TRANS/WP.29/2004/21
5 December 2003

PROPOSAL FOR DRAFT SUPPLEMENT 7 TO THE 01 SERIES
OF AMENDMENTS TO REGULATION No. 52

(Small capacity passenger vehicles, M2 and M3 category)

Transmitted by the Working Party on General Safety Provisions (GRSG)

"Figure 15b

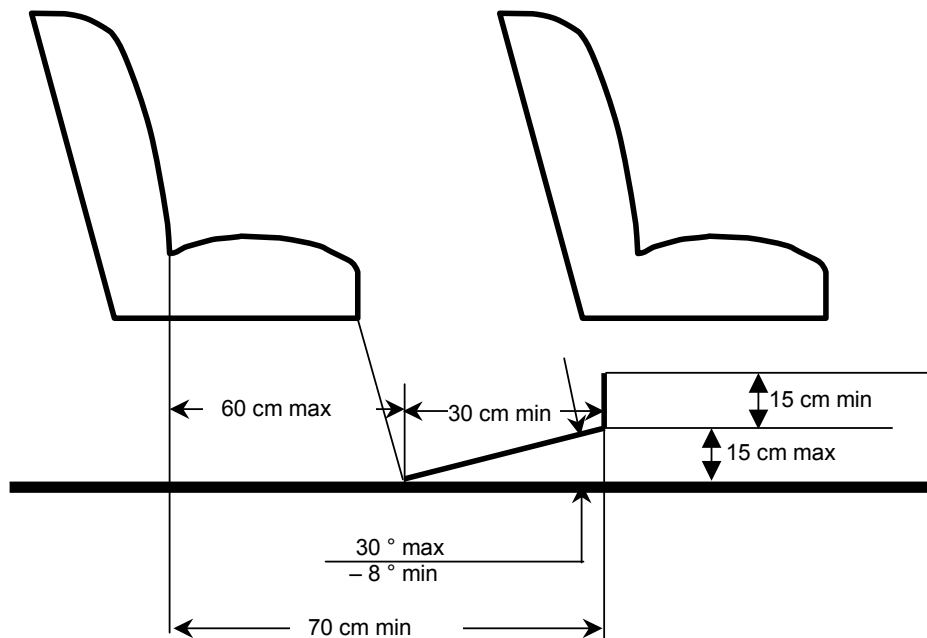
Insert a new figure 15b, to read:

SPACE FOR SEATED PASSENGERS BEHIND A SEAT AND/ OR A SEAT FACING THE
GANGWAY
(see paragraph 5.7.8.5.2)

"5.7.8.5.2. For a seat behind a seat and/or a seat facing the gangway, a minimum clear foot space of at least 300 mm depth and a width according to paragraph 5.7.8.2.1. shall be provided as shown in annex 3, figure 15b. The local presence in this space of seat legs and of intrusions as provided by paragraphs 5.7.8.1.3.3. and 5.7.8.1.3.4. shall be permitted provided that adequate space remains for the passengers' feet. This foot space may partly be situated in and/or above the gangway but shall not create any obstruction when measuring the minimum gangway-width in accordance with paragraph 5.7.5. Intrusion of the seat belts and seat belt anchorages shall be allowed."

“Figure 21
ACCESS TO DRIVER’S DOOR
(See paragraph 5.6.2.5.2.)

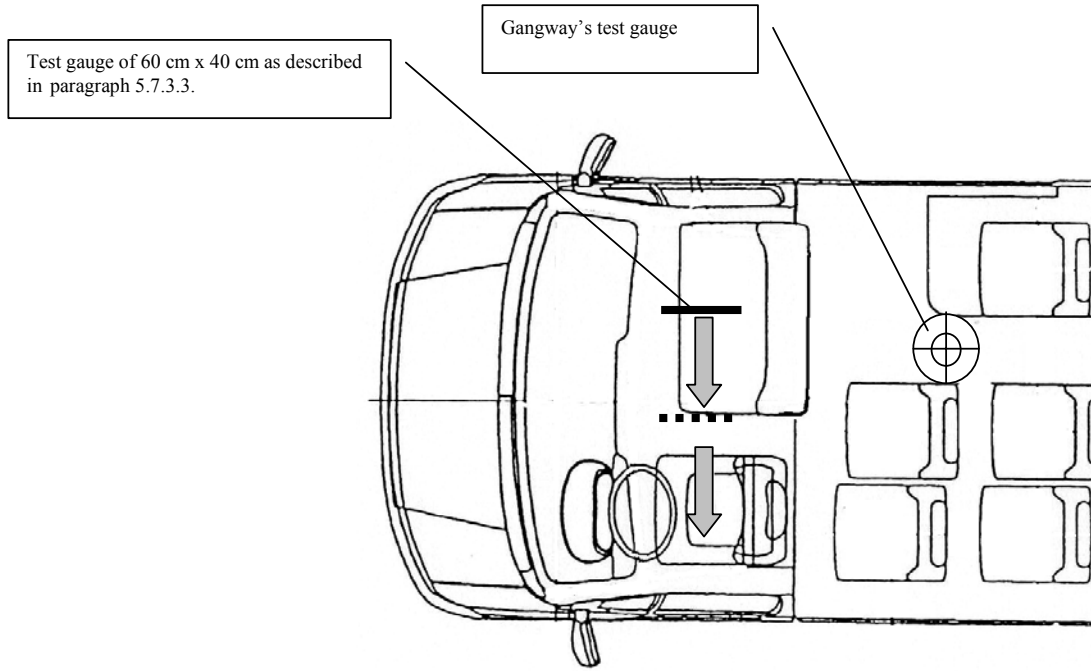
Insert new figures 21 and 22, to read:

"5.6.2.5.2. The driver's door shall be accepted as the emergency door for the occupants of the seats situated beside the driver's seat provided that it is possible to move a test gauge from the occupants' seats to the exterior of the vehicle through the driver's door (see annex 3, figure 21).

Verification of the access to the driver's door shall be subject to the requirements of paragraph 5.7.3.2., by using the test gauge having a dimension of 600x400 mm, as described in paragraph 5.7.3.3. The service door provided for the passengers shall be in the side of the vehicle opposite to that containing the driver's door and shall be accepted as the emergency door for the driver;"
